J19D012

DRAINAGE PLAN

ASHCRAFT-SANDIA OFFICE BUILDING
GRADING & DRAINAGE PLAN

REF: ASHCRAFT SANDIA OFFICE BUILDING (J19-D12) MAY 9, 1984

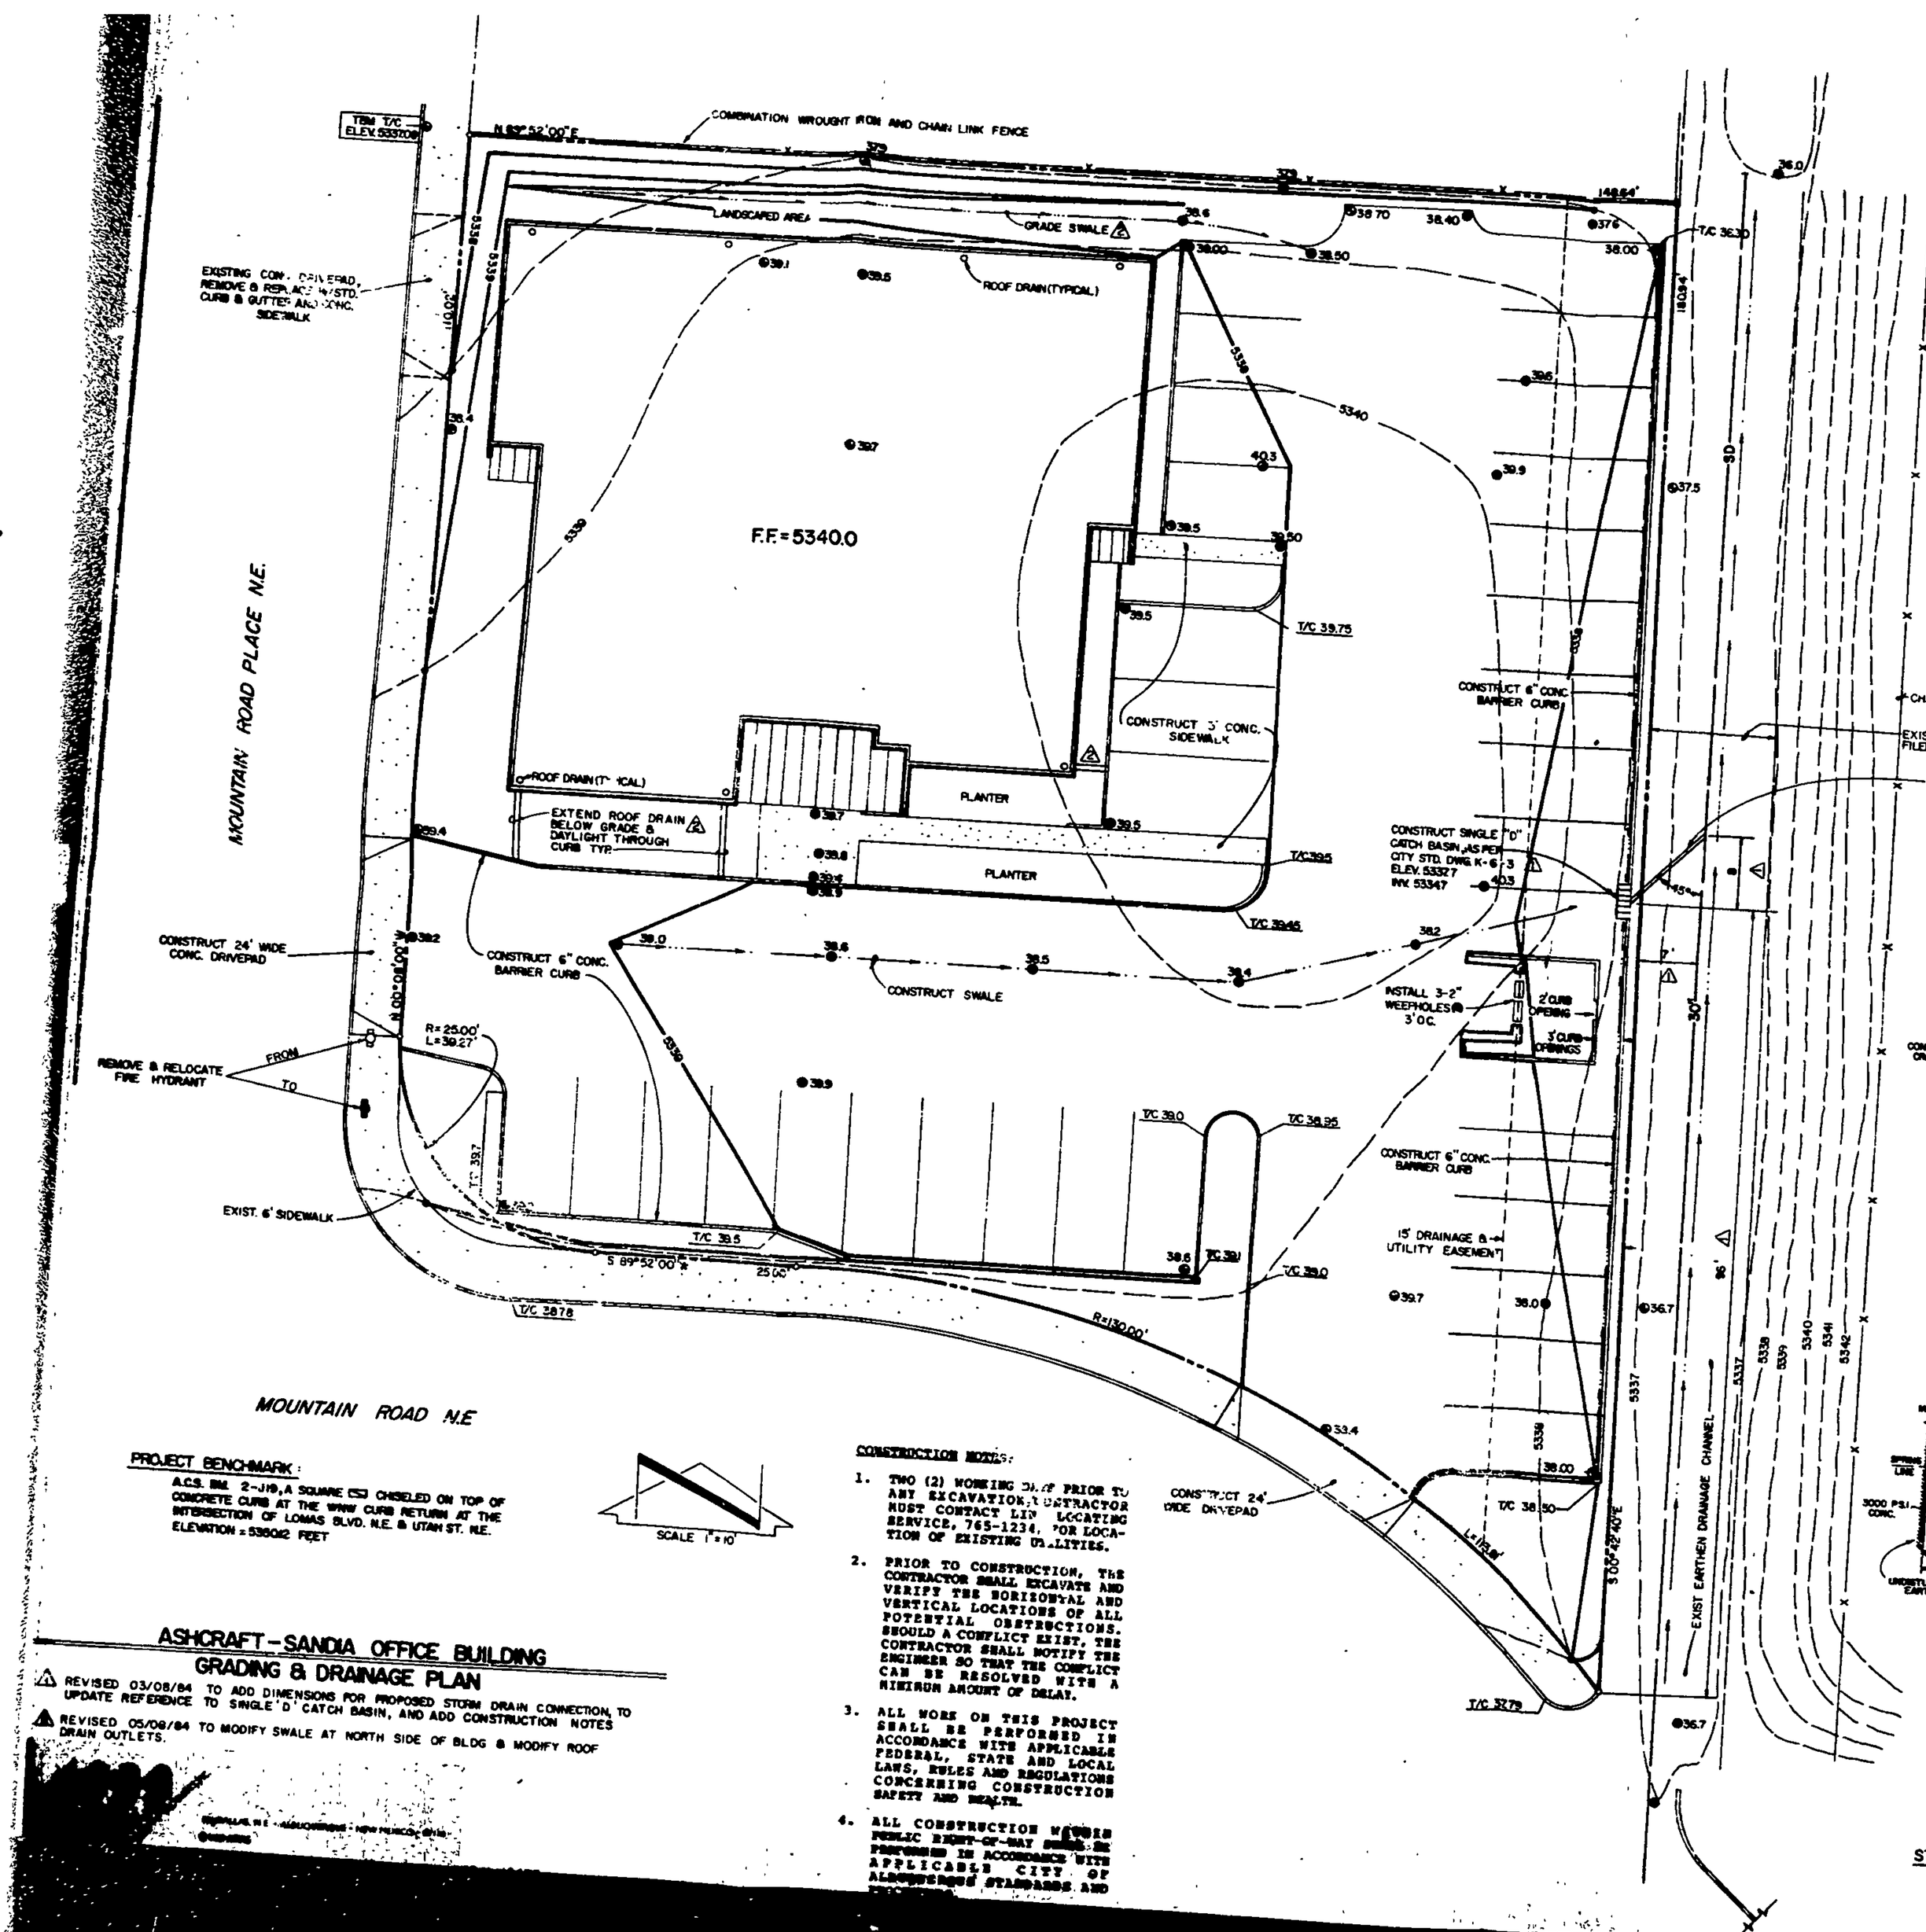
△1 REVISED 03/08/84 TO ADD DIMENSIONS FOR PROPOSED STORM DRAIN CONNECTION, TO UPDATE REFERENCE TO SINGLE 'D' CATCH BASIN, AND ADD CONSTRUCTION NOTES
△2 REVISED 05/08/84 TO MODIFY SWALE AT NORTH SIDE OF BLDG & MODIFY ROOF DRAIN OUTLETS.
